Architectural Review Board Meeting Agenda
Tuesday, January 20, 2026, 4:00PM Norfolk
City Hall, 810 Union Street, 11th Floor

#26-00352 Certificate of Appropriateness Report

#25-99 Certificate of Appropriateness Report

#25-48 Certificate of Appropriateness Report

Window Inventory with descriptive information and component assessment.

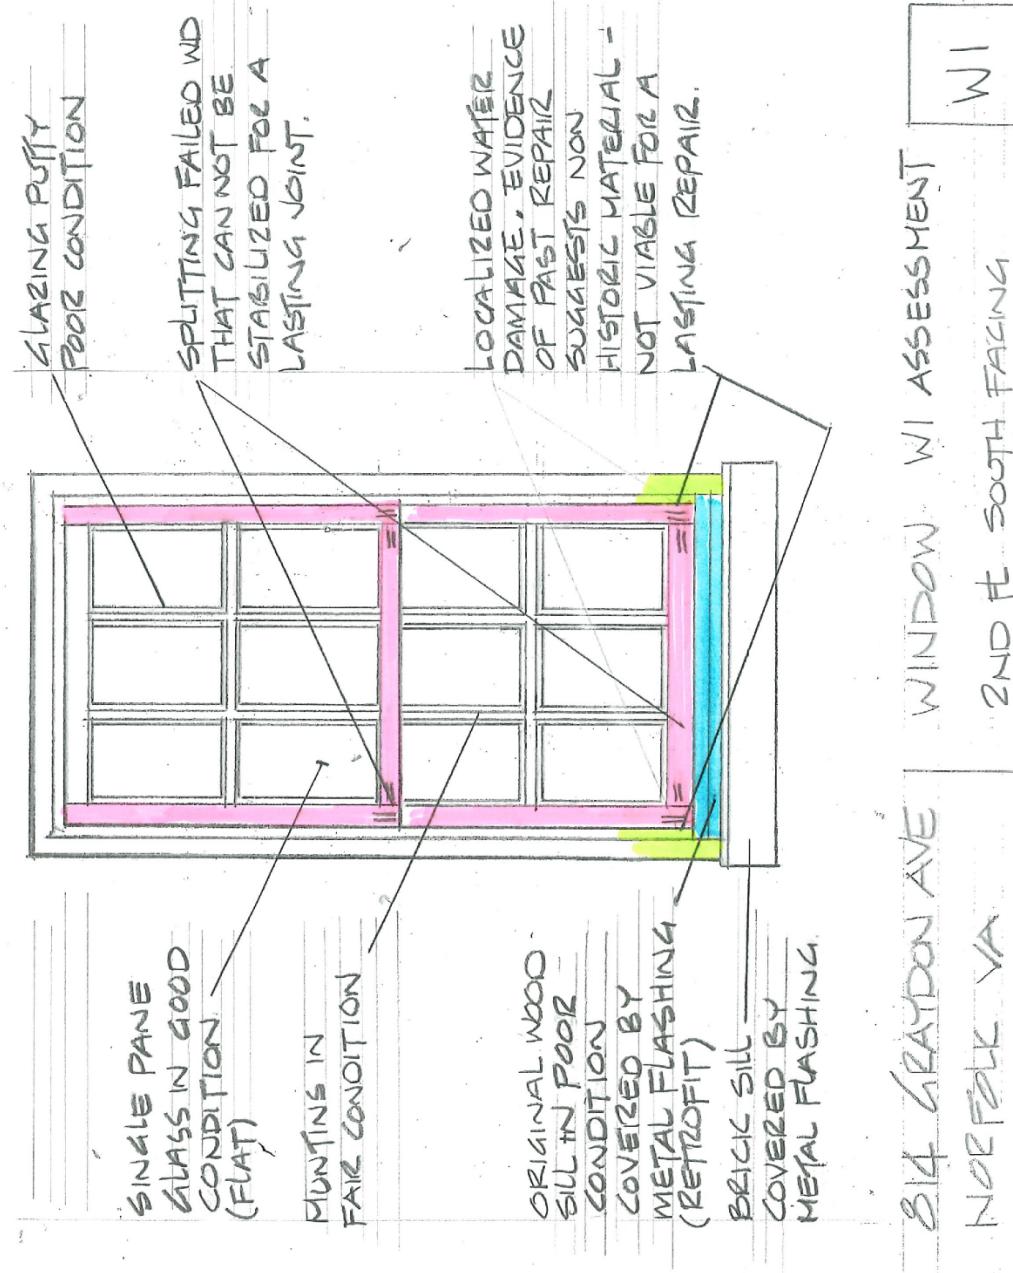
Comment from applicant: "It appears that the metal sill flashing was installed sometime after the original windows was installed – see attached fasteners in attached photo – this suggests that there was no original concealed sill flashing pan. Which suggests that a water intrusion issue was discovered and correct by an "exposed pan" – to correct this installation the window frame would need to be pulled out, and a new pan installed."

Dimensions of the existing and proposed grille profile.

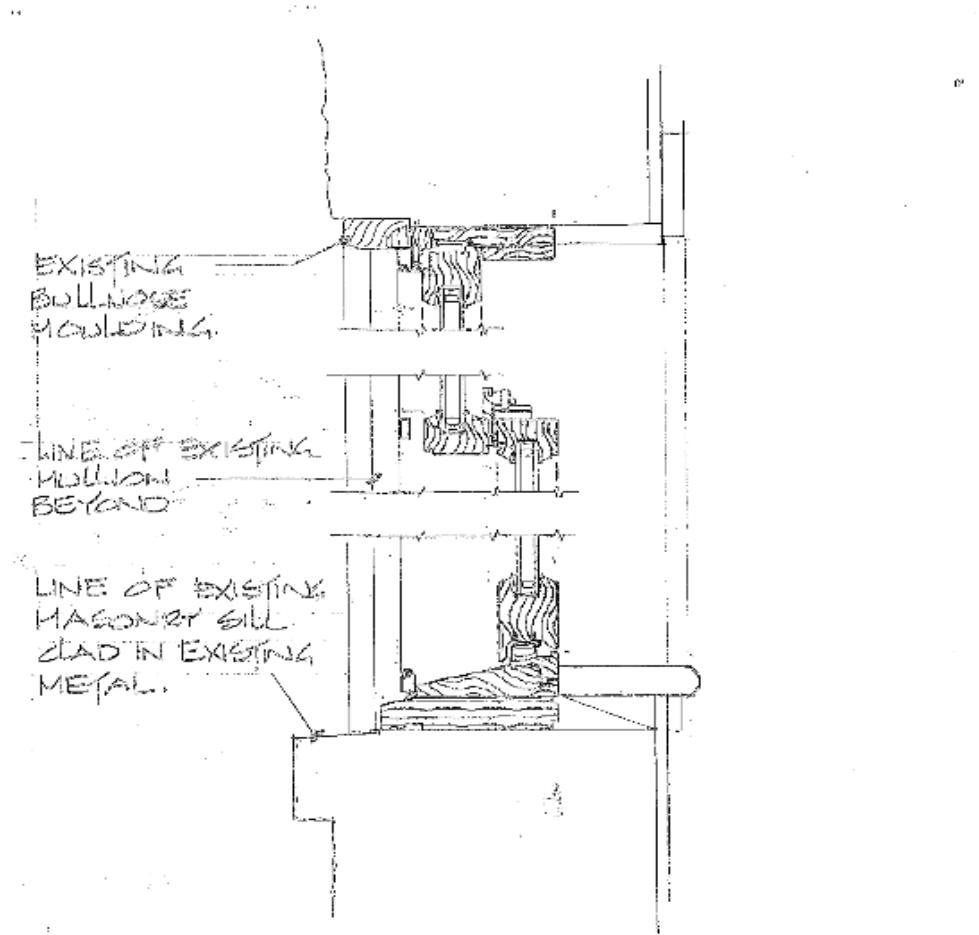
In-kind replacement of materials and features are typically exempt from review; this proposal, however, includes slight deviations in the dimensions of the grille profile, jambs, rails, and sill and are simulated-divided lights (SDLs).

Component	Existing	Proposed	Difference
Grille profile	$\frac{3}{4}$ inch	$\frac{5}{8}$ inch	$-\frac{1}{8}$
Upper Jamb/Lower Jamb	$1 \frac{3}{4}$ inch	$1 \frac{7}{16}$ inch	$-\frac{5}{16}$
Upper Rail	$1 \frac{1}{4}$ inch	$1 \frac{15}{16}$ inch	$+\frac{11}{16}$
Check Rail	$1 \frac{3}{8}$ inch	$1 \frac{7}{16}$ inch	$+\frac{1}{16}$
Bottom Rail	$3 \frac{1}{4}$ inch	3 inches	$-\frac{1}{4}$
Subsill	$1 \frac{3}{4}$ inch	$1 \frac{1}{8}$ inch	$-\frac{5}{8}$

The proposed replacement wood window is consistent with the guidelines. Slight dimensional variations in the proposed window components will be minimally noticeable, given the locations on the second floor. Given the failure of past repairs, the current conditions, and the near match of the proposed replacement window, Staff believes replacement is supportable and preserves integrity of the building. The building currently has a mix of window types, with the majority being vinyl replacements. Using wood to

Front elevation of proposed porch and second floor deck reconstruction.

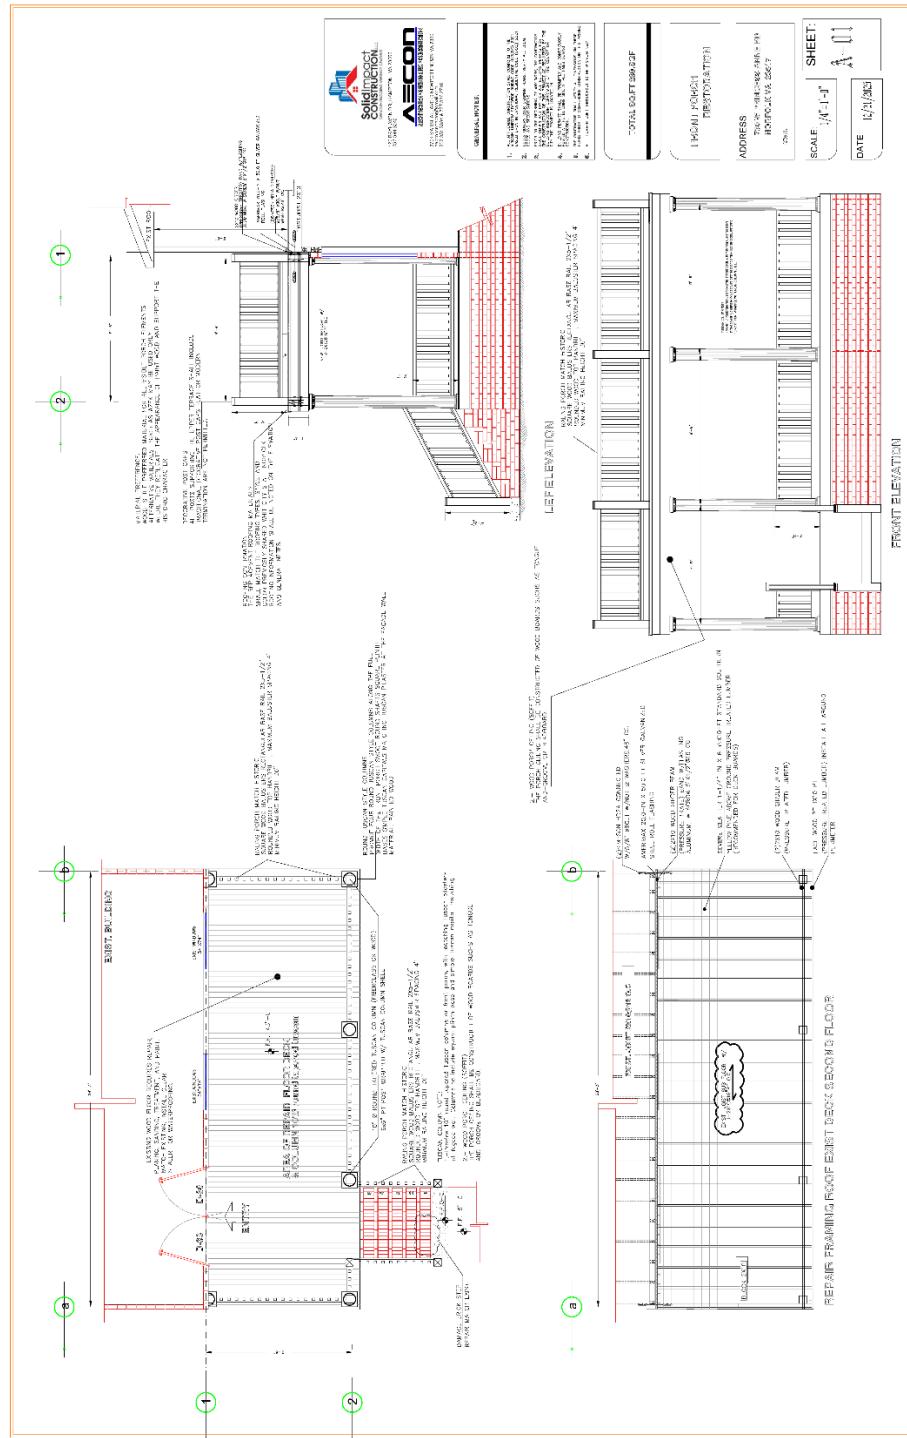
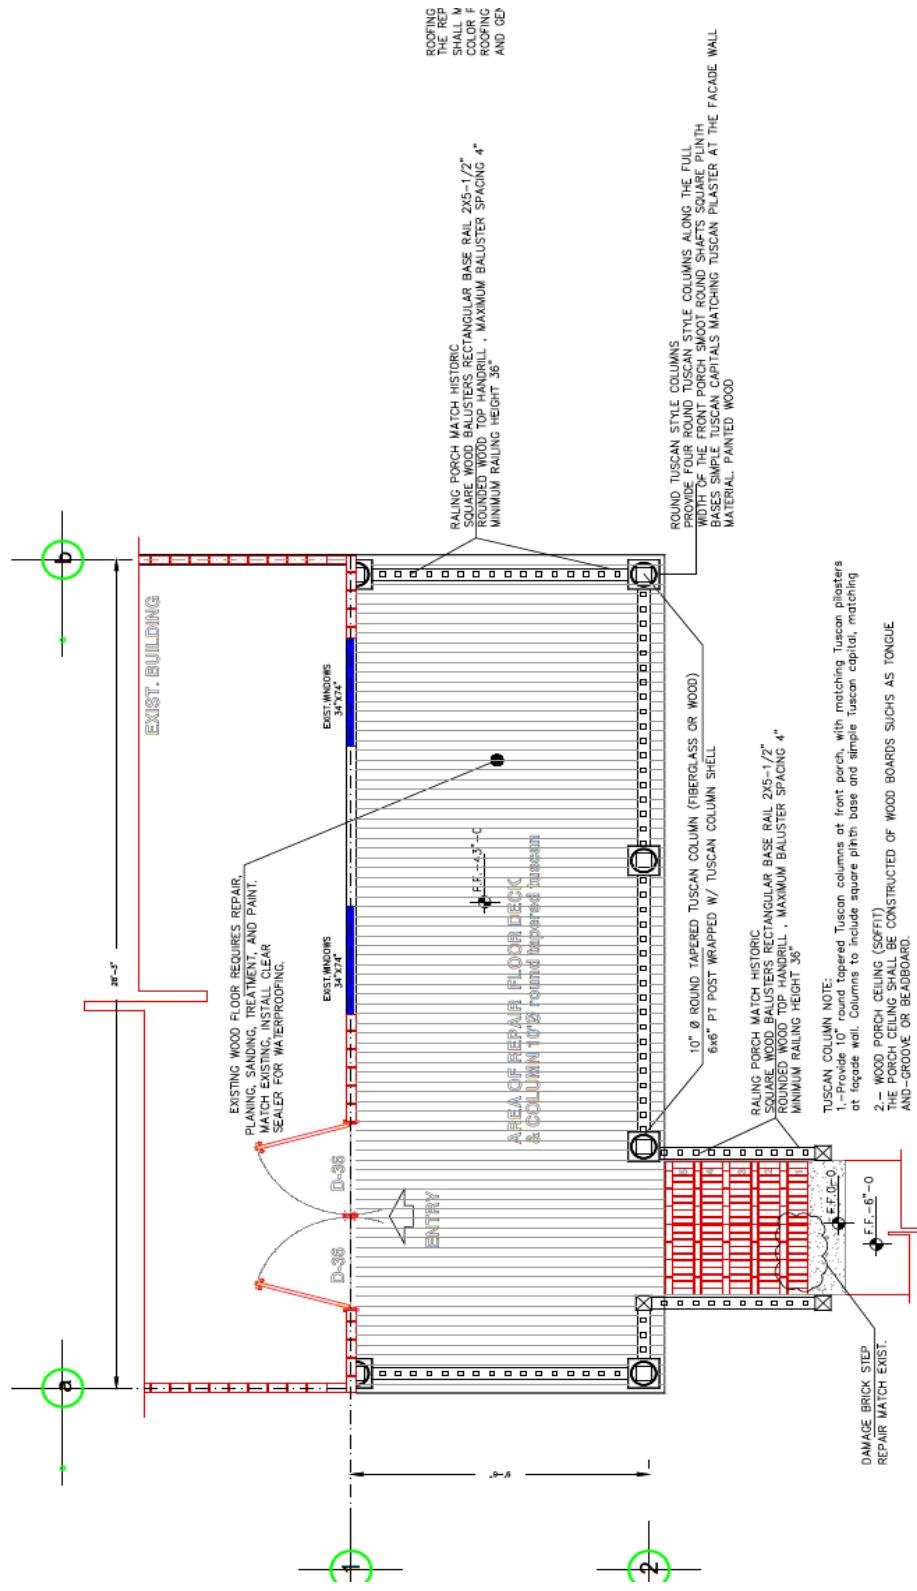
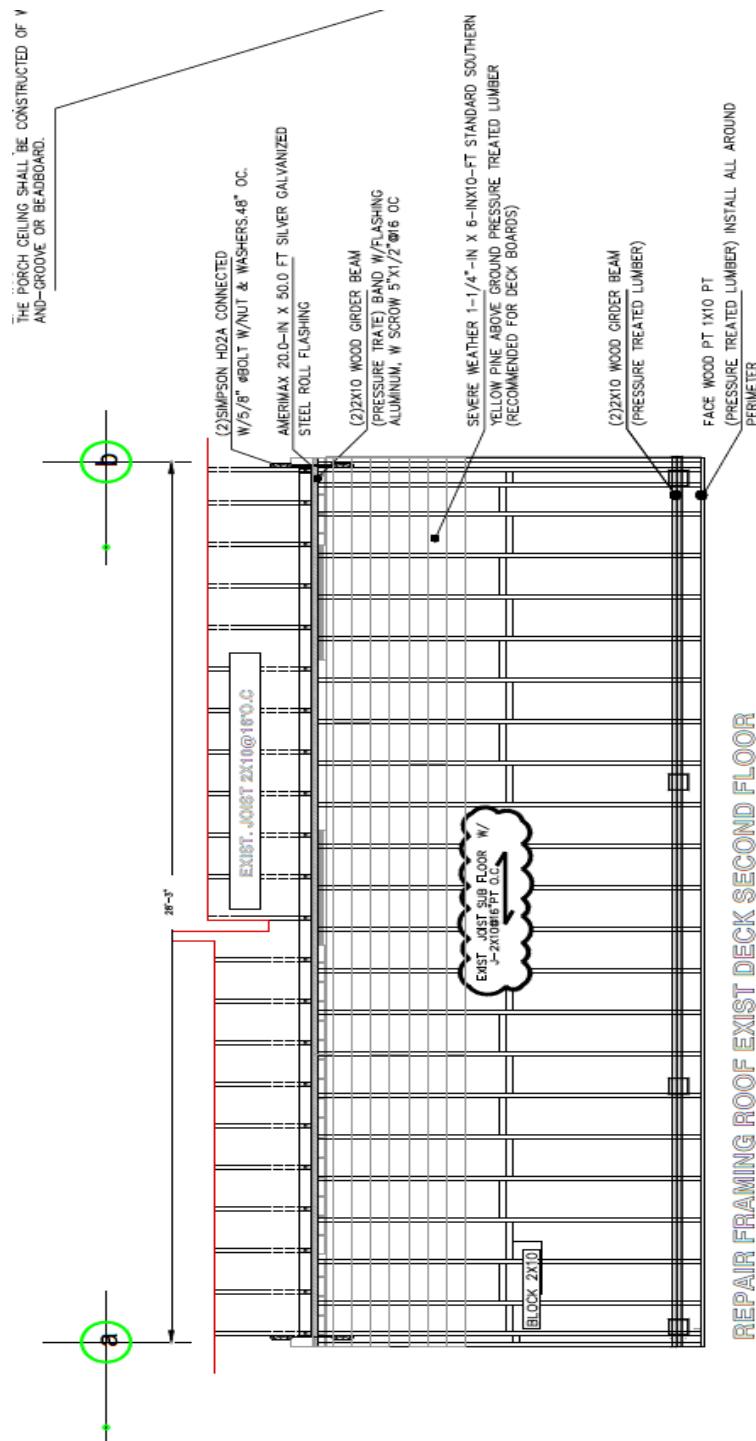
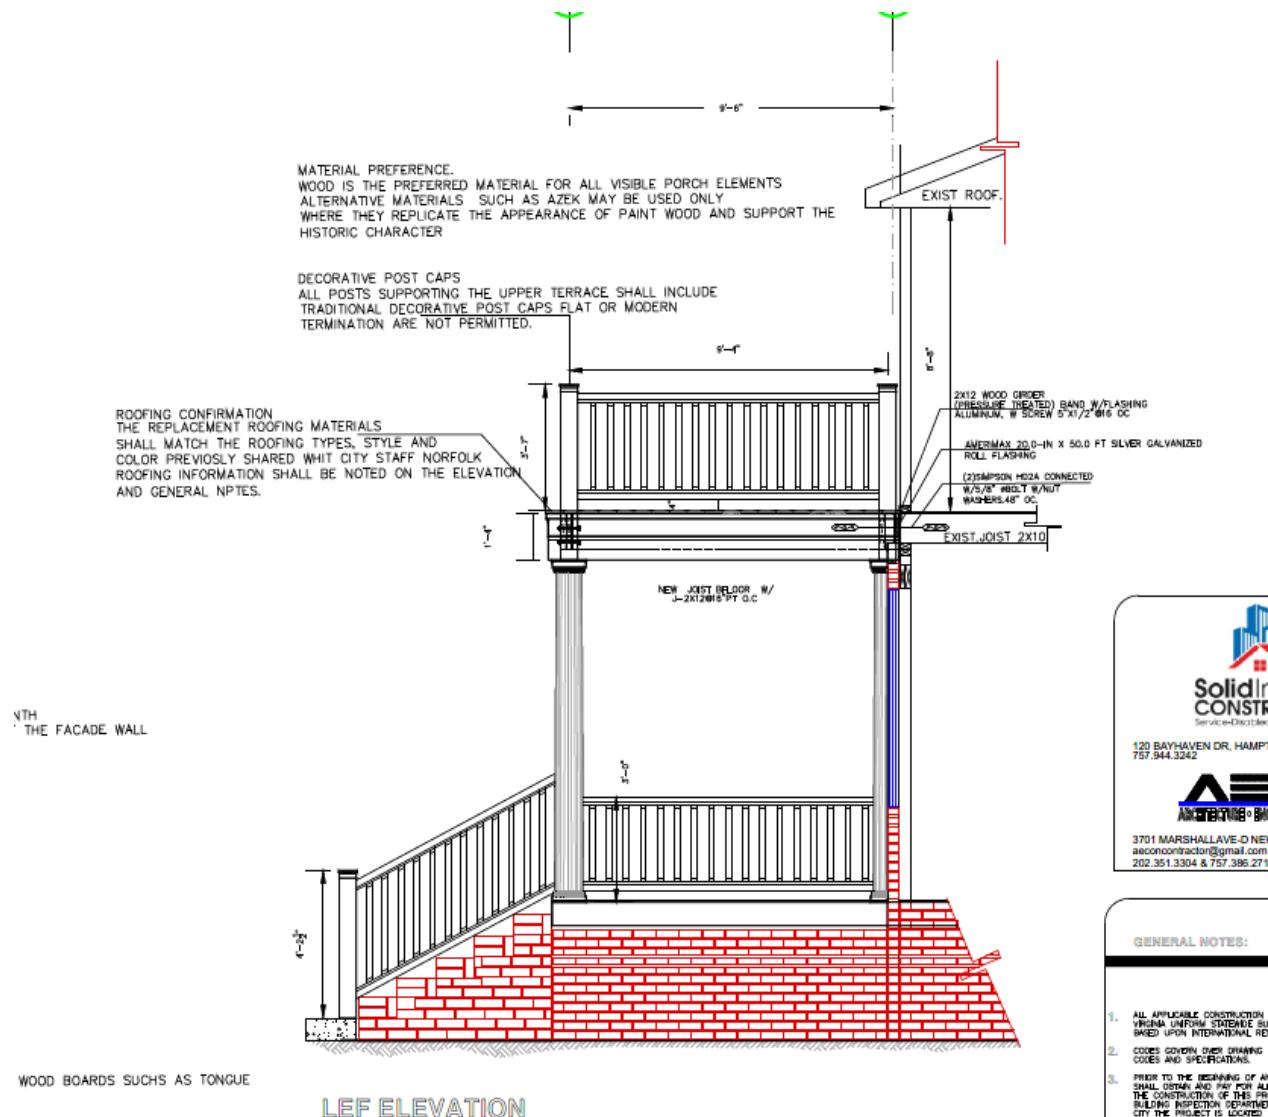
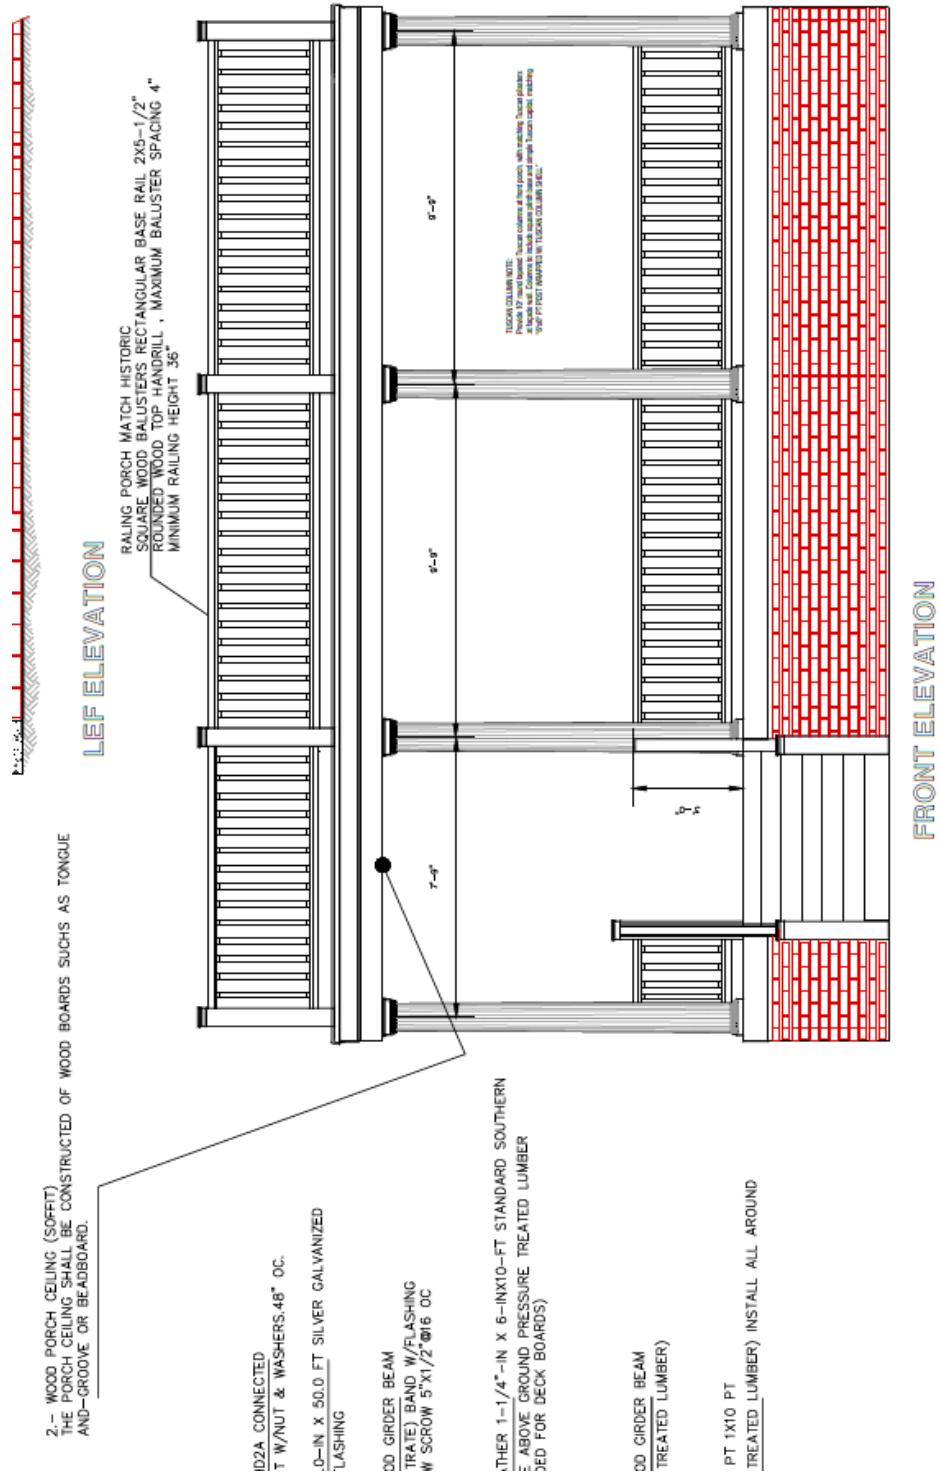
The applicant proposes to reconstruct the porch roof and install four Tuscan columns with matching Tuscan pilasters to support a flat roof that will serve as the base for a second story deck. The columns will be the 10-inch diameter Endura-Series Composite Architectural Columns, that will wrap a 6-inch by 6-inch structural post within the Tuscan column shell. Each column will include a simple square plinth base. The porch railing will have square wood balusters, a rectangular base rail, and a rounded wood top handrail. For the porch ceiling, the applicant is considering either wood tongue-and-groove boards or beadboard. The applicant has indicated that the existing wood floor will be repaired and finished with paint.

A flat porch roof is proposed that is similar to the previous and will support the second-story deck. EPDM roofing will be installed as the underlayment for the deck base. In email correspondence, the applicant indicated that the wood decking boards will be installed perpendicular to the house, although the submitted drawings show them parallel. The second-story deck railing will be a simple balustrade with square balusters and rails. Wood posts will be capped with decorative pyramid-style wood caps. It is noted on the submitted drawings that the preferred material for all components is wood but also says “alternative materials such as Azek may be used only where they replicate the appearance of paint [sic.] wood and support the historic character.”

The 1940s Tax Assessor photograph shows round columns supporting the porch. The most recent porch columns were square; the applicant proposes to use composite Tuscan columns. Staff finds that Tuscan columns are appropriate for the new porch, as historical evidence indicates the original columns were round. Using Tuscan columns will not create a false sense of history, given sufficient documentation to support recreating the round column. The use of composite material for the replacement columns is appropriate, as it is not replacing original wood columns. Staff finds the proposed 10" diameter of the columns to be appropriate for proportions of the porch.

General note on materiality: The plans submitted by the applicant identify wood for most of the porch materials but there is also the previously mentioned note that indicates alternative materials such as Azek might be used. Staff recommends wood for porch elements, per the Historic District Design Guidelines, however, the guidelines do allow for alternative materials like Azek for porch elements. To clarify the plans the applicant submitted, Staff recommends Condition 4: if an alternative material is selected for any porch components, product details must be submitted for review.

1. New wood shingles shall be finished with either paint or stain.

2. The wood balustrades on the porch and the second story shall be painted.
3. Should repair of the existing floorboards be infeasible, wood, Trex, or a similar synthetic product to Trex of dimensions matching the historic flooring may be used to replace the porch flooring following review of the product information by Staff.
4. Wood shall be the primary materials for porch components; if an alternative material is proposed in lieu of any wood feature as shown on the plans, product information shall be submitted for Staff review and approval before use.
5. The porch ceiling shall be beadboard and painted.
6. The flooring for the second-story deck shall run perpendicular to the building.
7. The Certificate of Appropriateness shall expire one (1) year after the date of Architectural Review Board approval.

Approved material palette.

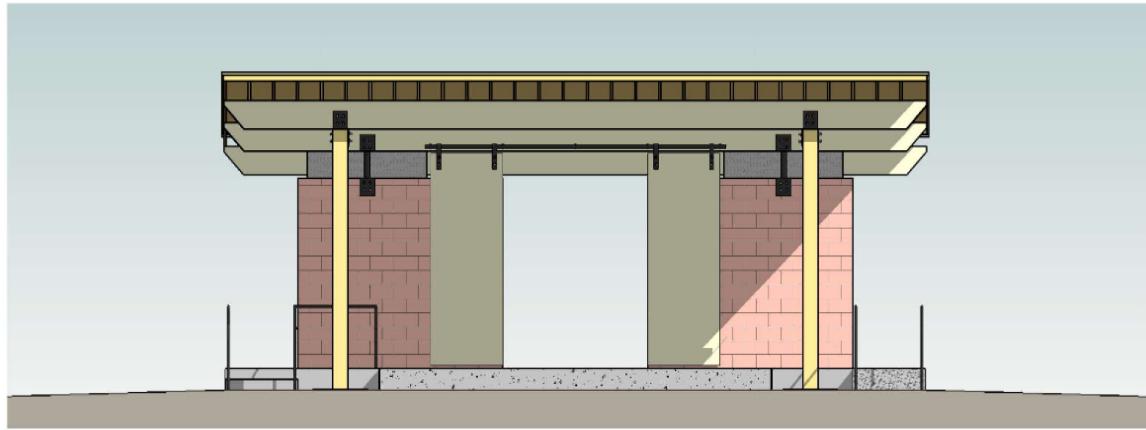
The contractor is unable to source the selected CMU—York Building Products Gemstone line in Claret—due to current lead times and the project timeline. To preserve the previously exhibited and approved color palette, a ground-face CMU in a matching red has been identified and is proposed as a replacement material. The color of the concrete is a near perfect match, however, the finish and aggregate are different. There is no discernible difference when rendering the material change in design software and likely will have only a few visual differences when seen from afar, however, there would be a difference up close when construction is completed.

While a honed face typically presents a more polished aesthetic, in Staff's opinion the proposed ground face CMU maintains the overall feel of the approved material palette and may provide a stronger contrast to the wood proposed for the stage canopy than the more mottled look of the original CMU. A honed face on CMU is more durable than a ground face and Staff has spoken with the applicant about whether any other honed-face CMU products are available in a timeframe that would meet the project timeline. The applicant is currently working on researching options.

1. The applicant shall research and confirm with City Staff that no other similarly colored, honed-faced CMU is available to complete the project within the established project timeline.
